Service Campaign Bulletin

Campaign No. 2018030007, April 2018

SUBJECT: **Model 205 Model Year 2018**
Replace Coolant Hose

Figure 1

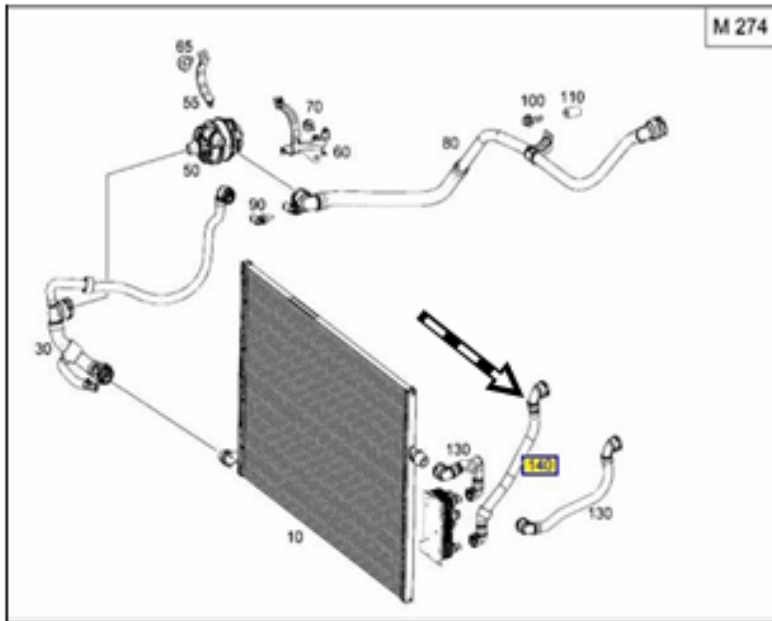
2. Replace **coolant hose (140)** in low-temperature circuit from oil cooler to charge air cooler (**figure 1**).
